SEWAGE TREATMENT PLANT NO. 3 (NW)

RE: SUB 2000-12 -- One Step Final Plat of SEWAGE TREATMENT PLANT NO. 3 (NW) ADDITION

STAFF REPORT
(One-Step Final Plat Approved 3/23/00)

CASE NUMBER: SUB 2000-12 -- SEWAGE TREATMENT PLANT NO. 3 (NW) ADDITION

SEWAGE TREATMENT PLANT NO. 3 (NW)

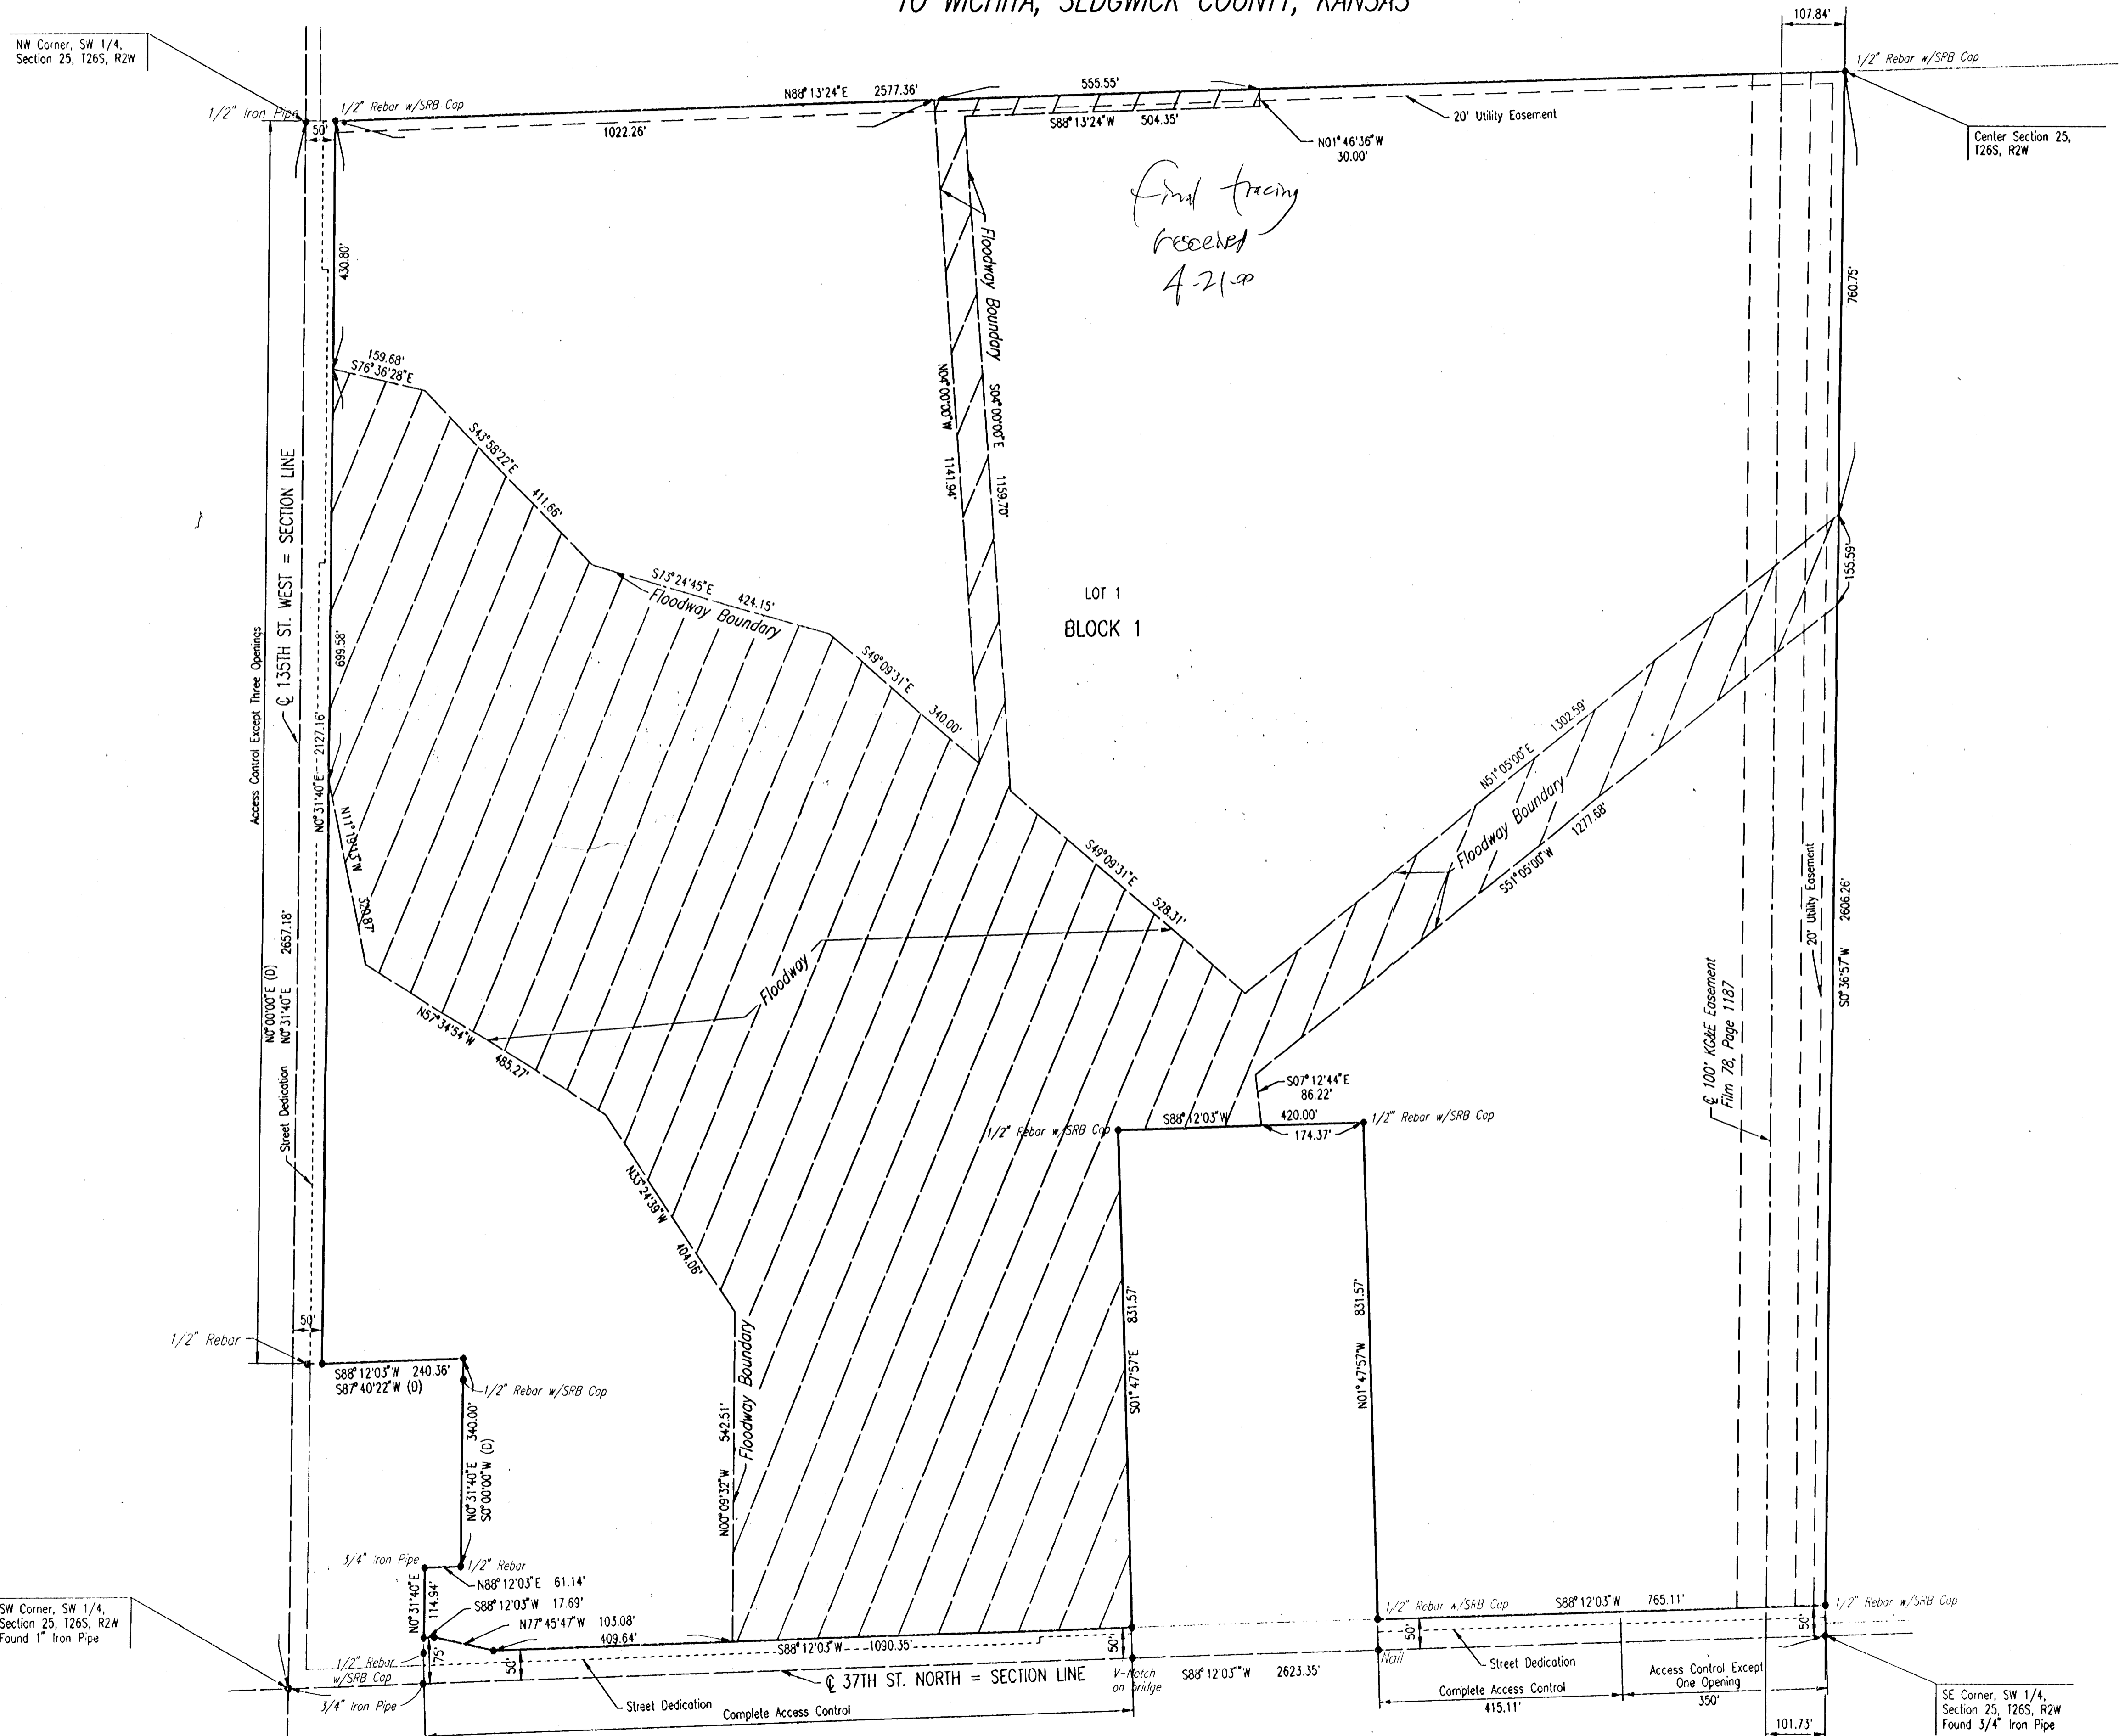
- C. City/County Engineering needs to comment on the status of the applicant's drainage plan. County Engineering requests the extension of the Floodway Reserve going north along the small tributary, and northeast along the large tributary.

- D. County Engineering needs to comment on the access controls. The plat proposes three access openings along 135th St. West and one opening along 37th St. North. The access controls are approved.

- E. County Engineering needs to comment on the need for improvements to 37th St. North and 135th St. West. The applicant shall guarantee the construction to the two-lane rural pavement standard of 37th St. North from 119th St. West to 135th St. West, and of 135th St. West from 37th St. North to the northern entrance of the site.

- N. The representatives from the utility companies should be prepared to comment on the need for any additional utility easements to be platted on this property. ***Southwestern Bell requests additional easements.***
